Subject: Supplemental Data Response, Set 2
Hidden Hills Solar Electric Generating System (11-AFC-2)

**Supplemental Data Response Set 2
(Boiler Optimization)**

Hidden Hills

(11-AFC-2)

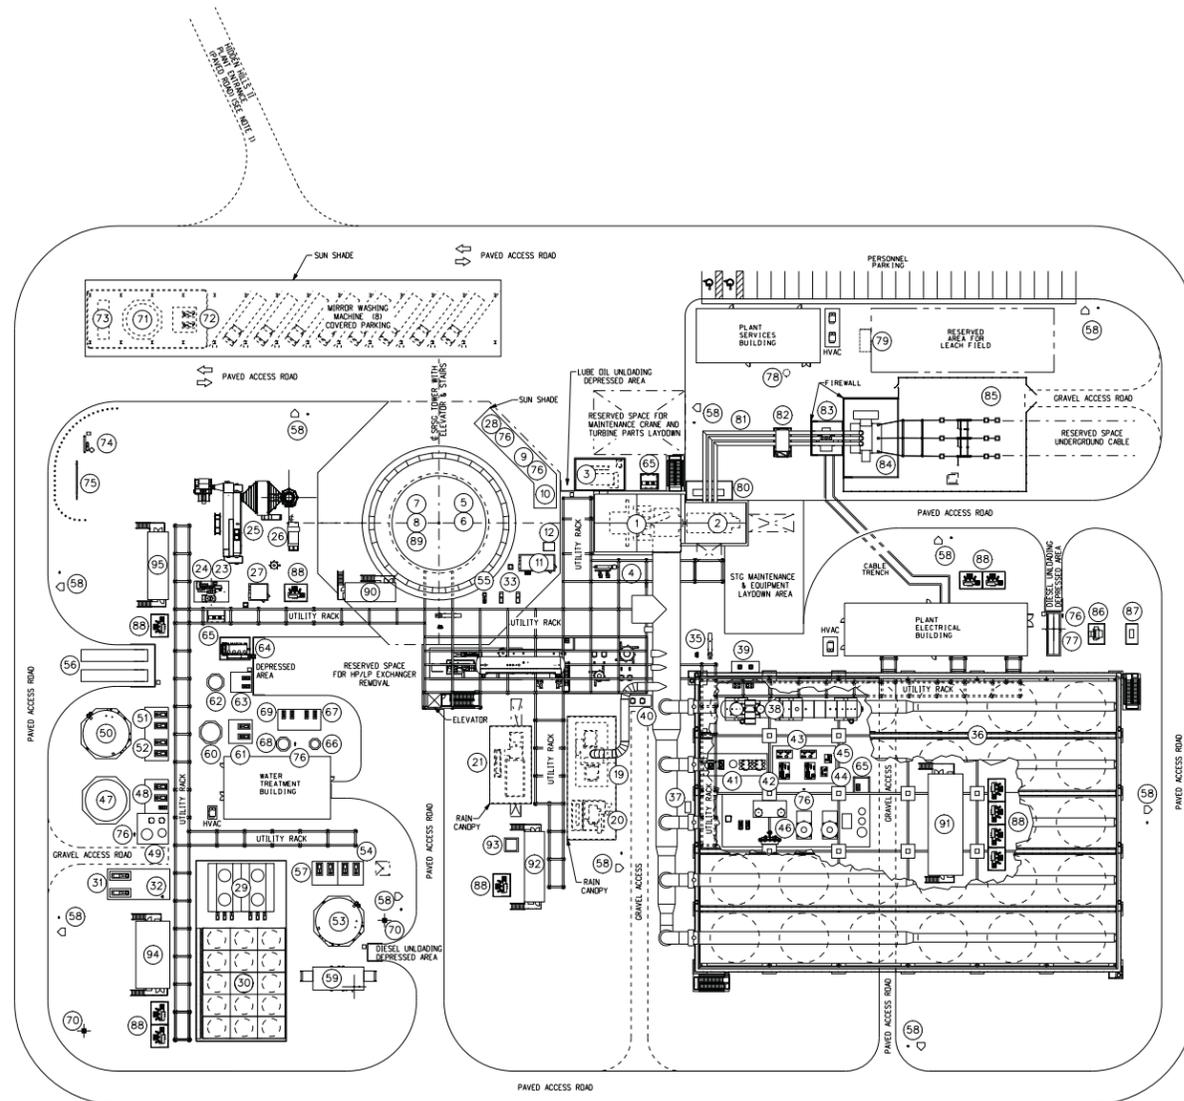
VR-5 Please provide a revised version of the KOP 5 simulation that depicts the correct location and scale of the project features and the most recent boiler design.

Response: All of the simulations, including the simulation from KOP 5, have been revised to reflect both the Boiler Optimization enhancements and the most recent design of the solar boiler, and all of these simulations have been prepared in a way that assures that they depict the project elements in the correct locations at the correct scale. These revised simulations are provided as Figures 5.13-2R1 through 5.13-7R1 and DR32-2R1. The revised simulation for KOP 5 is Figure 5.13-6R1 in this figure set.

FIGURE 2.2-1-R1
Power Block Plot Plan
Hidden Hills Solar Electric Generating System

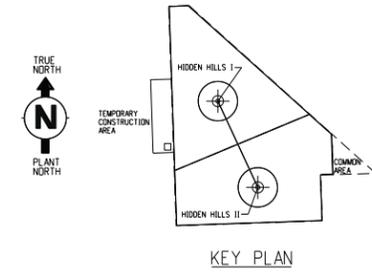
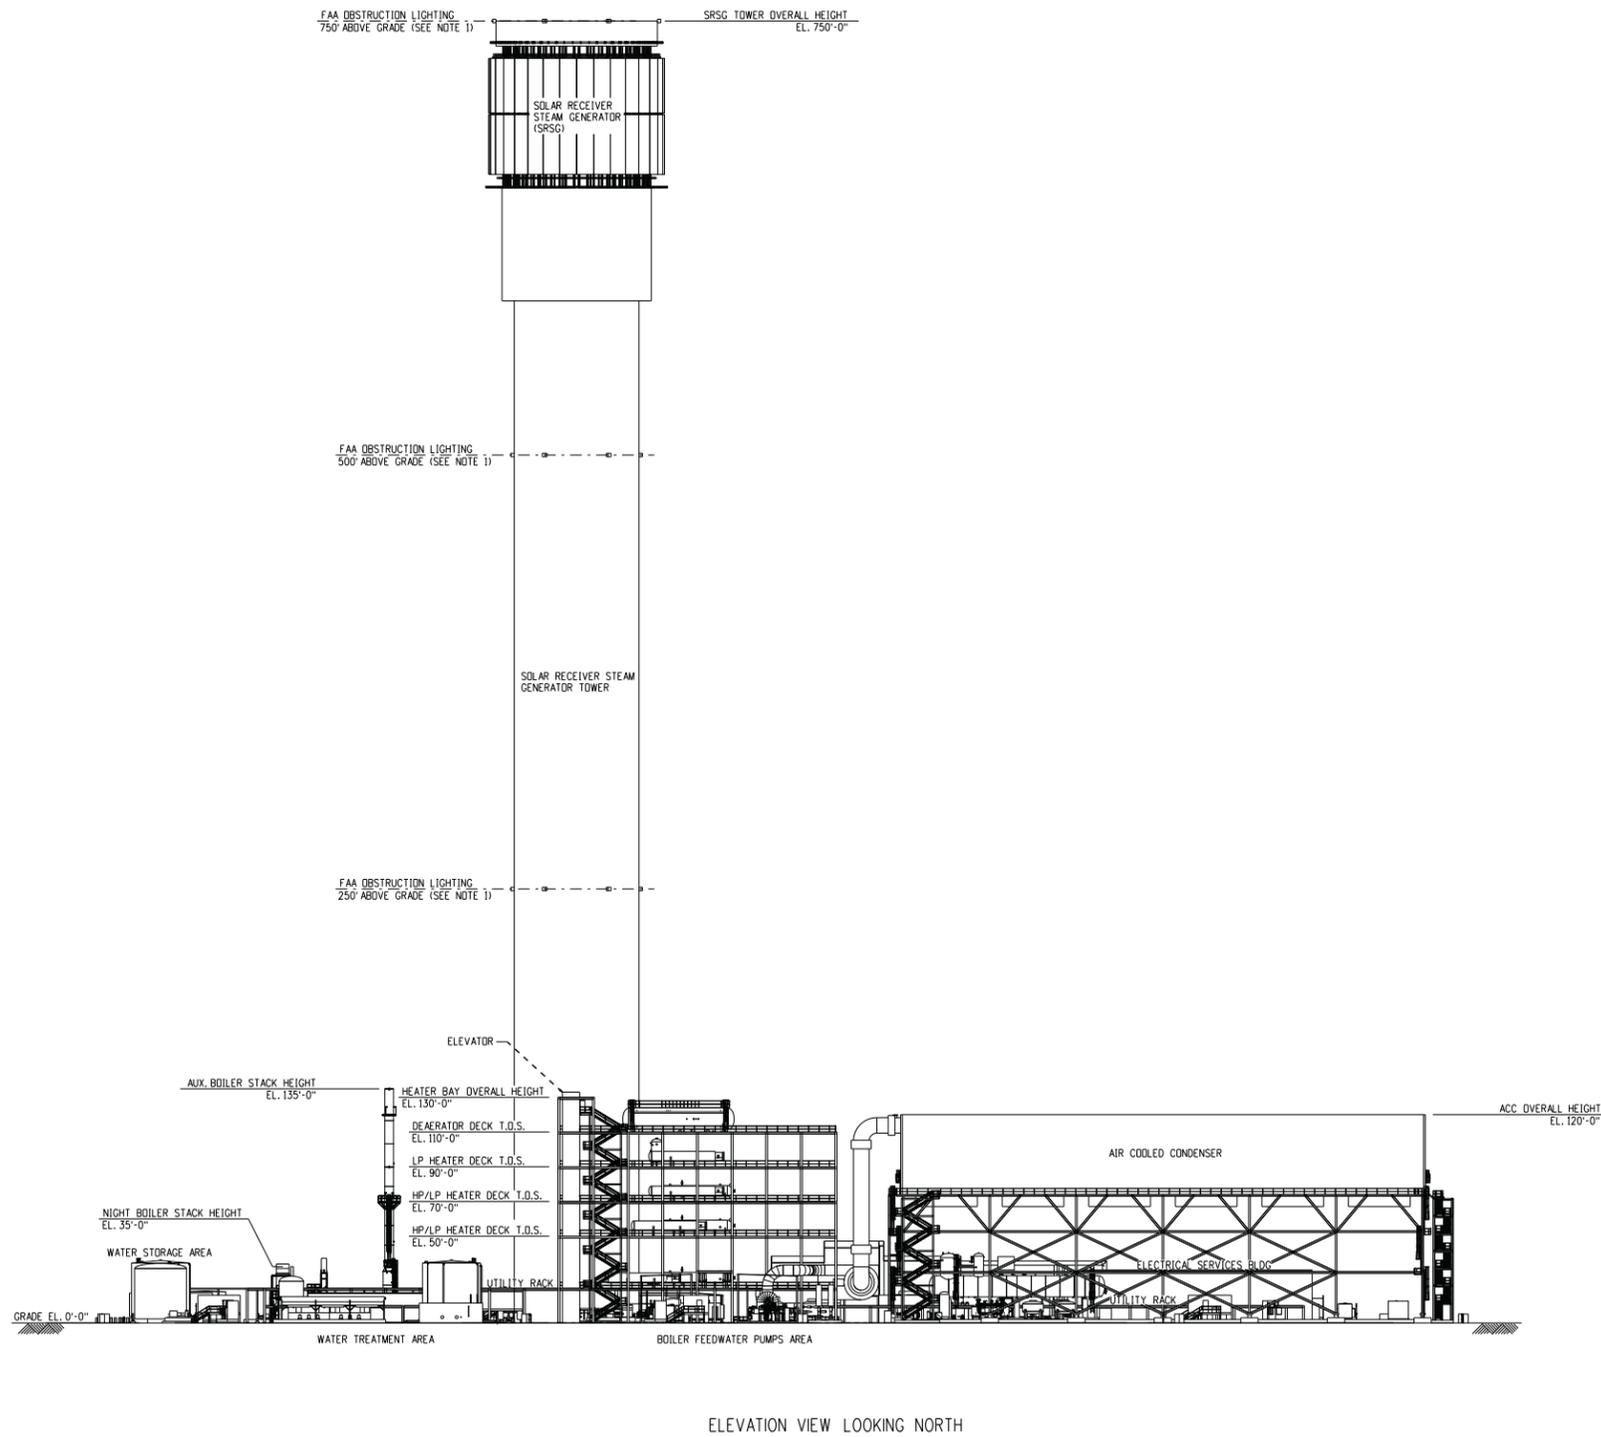
Given the removal of the large boilers, the annual natural gas use in the remaining two boilers under the optimized design will be reduced by about half compared with total gas use in the original design. Boiler Optimization will also reduce emission of greenhouse gas and criteria pollutants for HHSEGS under all scenarios. As a result of the optimization, the general arrangement of the power block has been revised. Figure 2.2-1R1 shows the

updated plot plan. In addition, Figures 2.2-2aR2 and 2.2-2bR2 provide revised elevation drawings. All figures are provided in Attachment A, Figures.

The Boiler Optimization will result in relatively minor changes to the project that are reflected in the revised plot plan (Figure 2.2-1R1) and the new elevation drawings (Figures 2.2-2aR2 through 2.2-2bR2). Table 5.13-4R1 (in Attachment B) replaces the version of this table that was included in the AFC Visual Resources chapter. This revised Table 5.13-4 includes a more comprehensive list of equipment than the original version of the table, and the dimensions have been revised where needed to reflect equipment changes related to the optimization enhancements.

FIGURE VR-1
Screen Shot of Digital Model for Visual Simulation
Hidden Hills Solar Electric Generating System

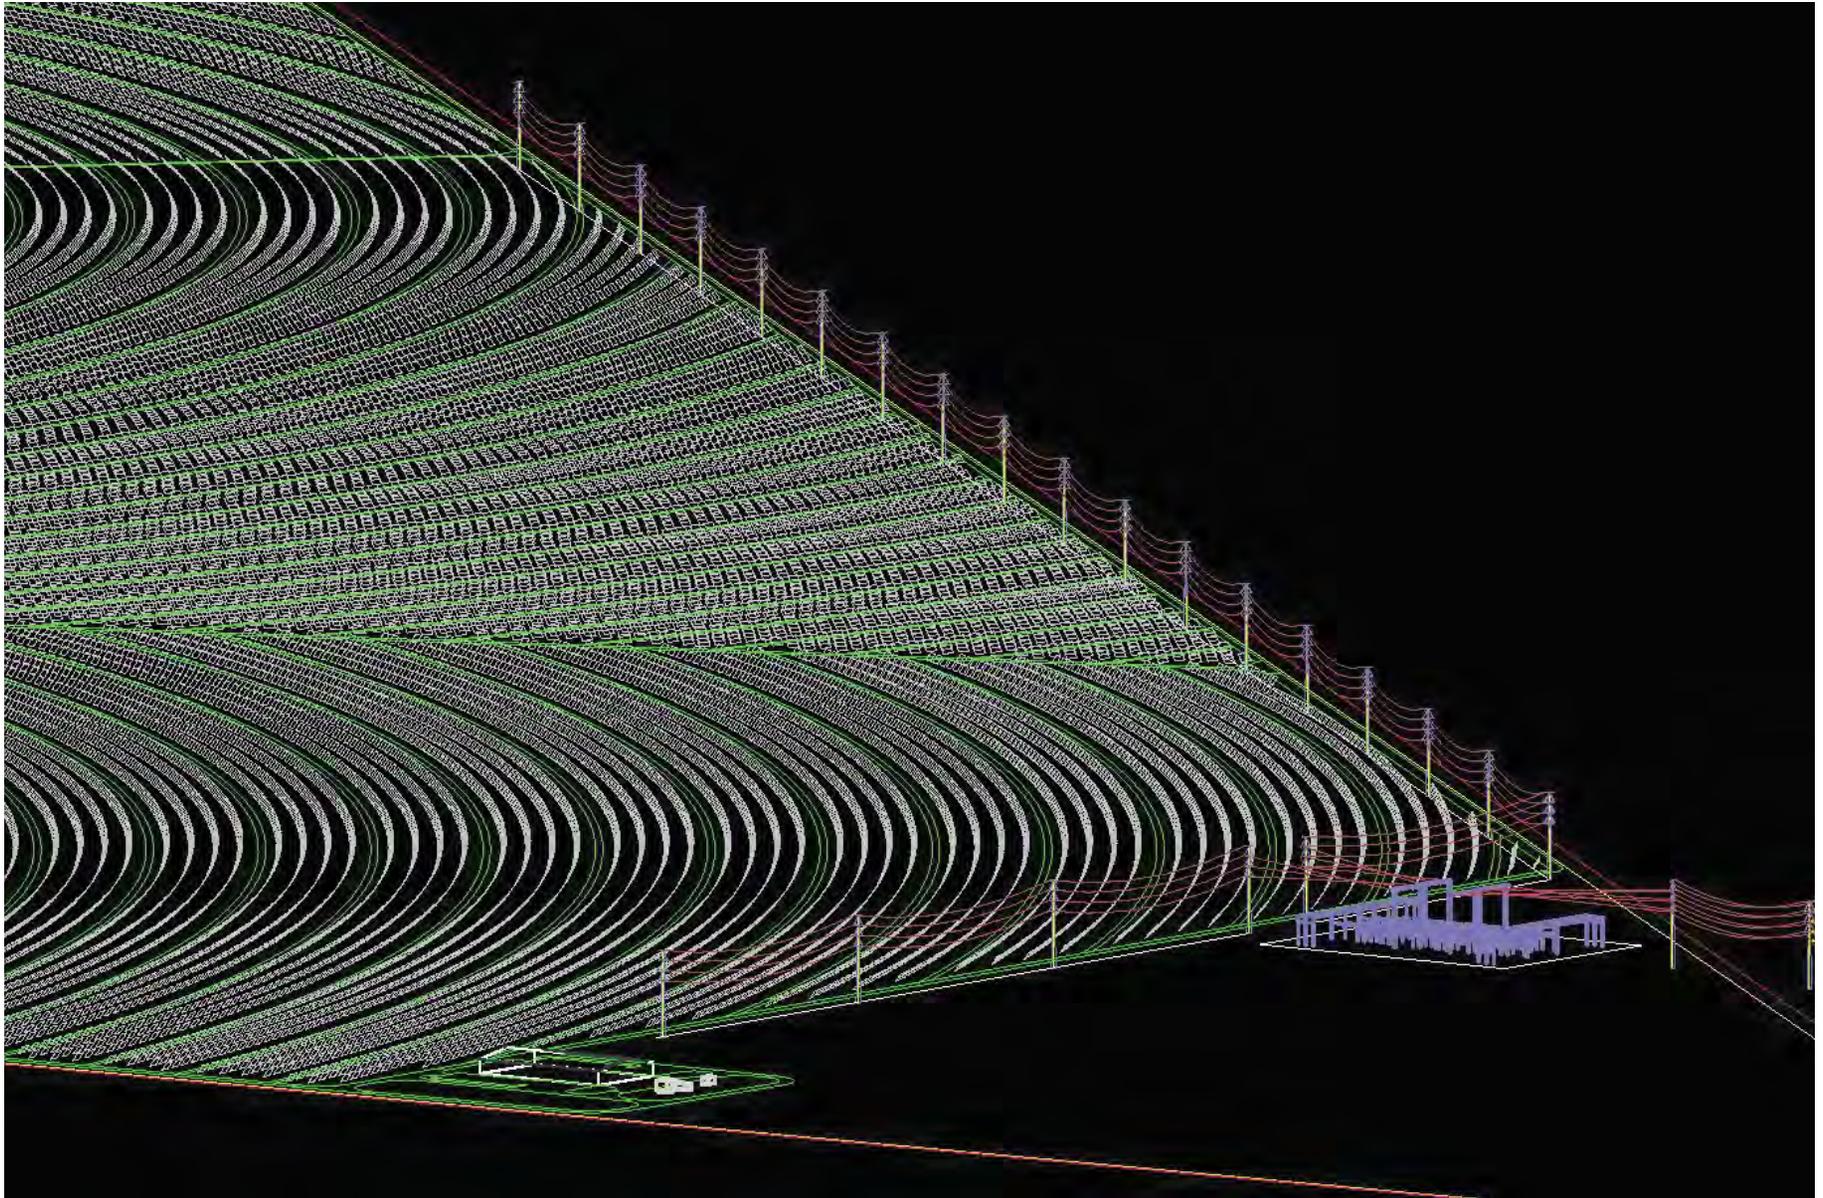
Response: A response was provided to the CEC by Tom Priestley via email on February 13, 2012. In the response he indicated that the Applicant “worked with our simulation specialist to take a very careful look at what was done in creating the simulation. Attached is a screen shot (refer to VR2-1, attached) that our simulation specialist provided of a portion of the digital model that was used to create the simulations. As you can see, the model we used included the transmission structures that carry the lines that transport the electricity from the power blocks to the switchyard. This screen shot also provides the answer to your question about how many transmission structures there are on the site.

FIGURE VR-2
View Cone Diagram for KOP 4
Hidden Hills Solar Electric Generating System

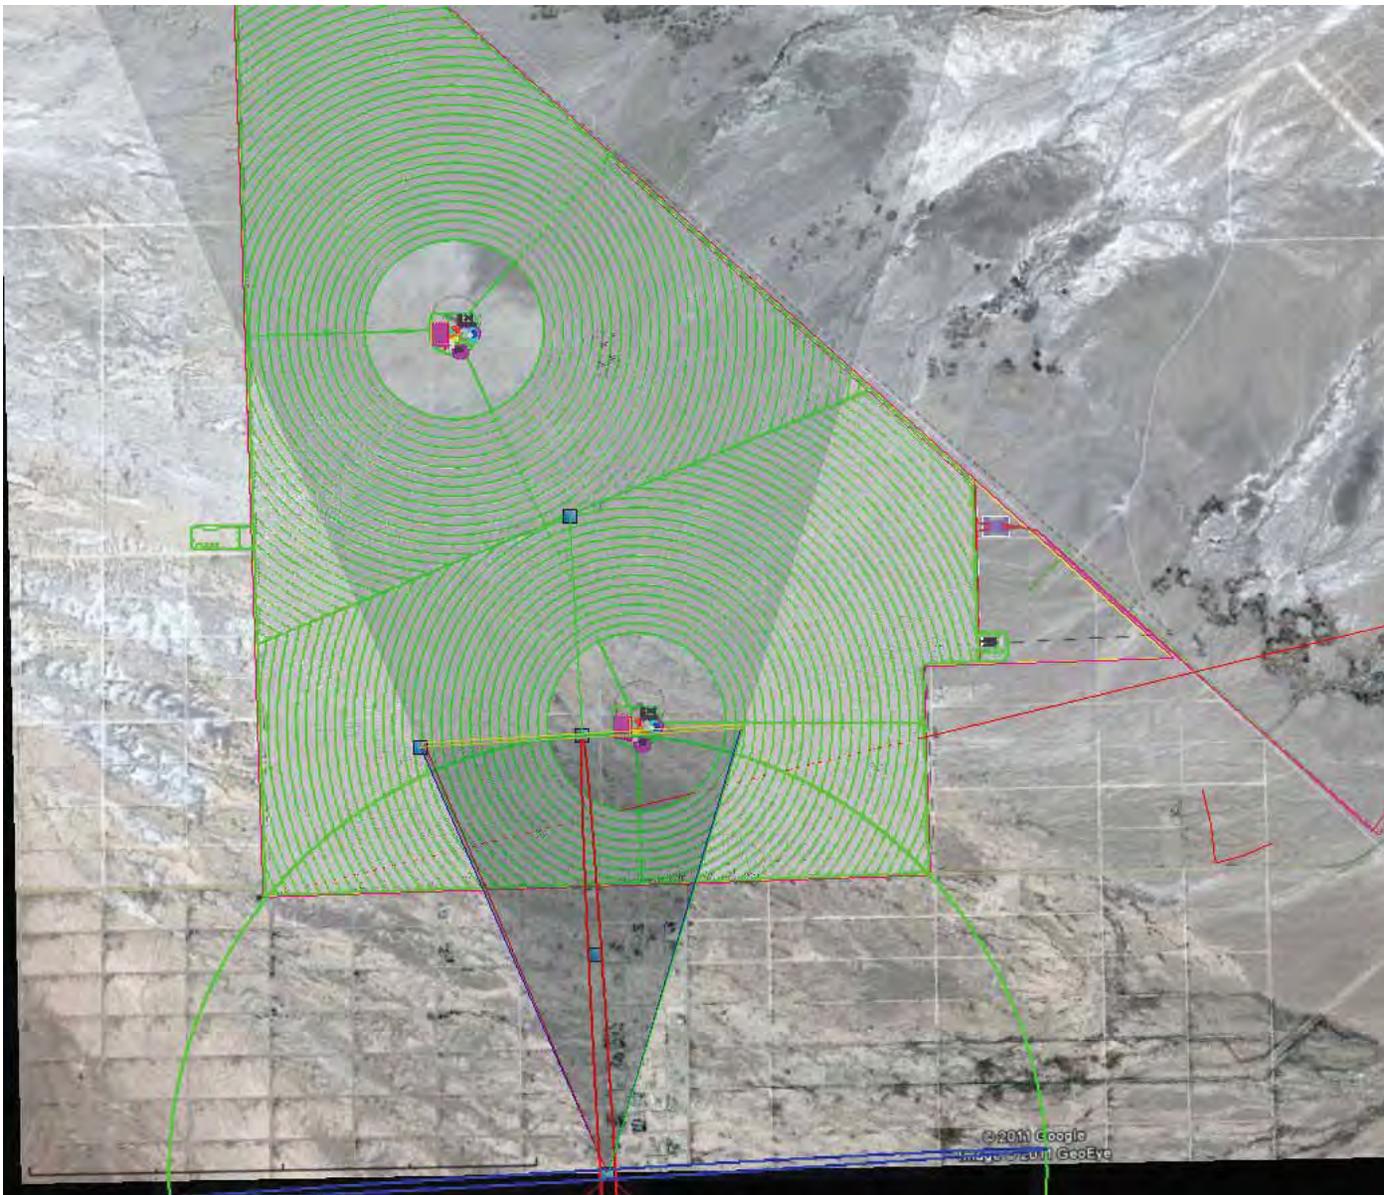
VR-2 Please provide an explanation as to why the viewer should, or should not, be seeing the onsite transmission system from KOP 4.

“The other file I have attached (see Figure VR2-2, attached) is a view cone diagram that provides an understanding of the physical relationships between the viewpoint and the various elements in the view. This diagram provides a basis for understanding that the

Subsequent to providing this data response, Applicant has made revisions to the location of the switchyard that will eliminate the need for aboveground transmission lines on the project site. Therefore, the number and appearance of the onsite transmission structures is no longer an issue. With the Boiler Optimization enhancements and relocation of the switchyard offsite, all onsite gen-tie lines will be undergrounded, eliminating all onsite transmission structures.
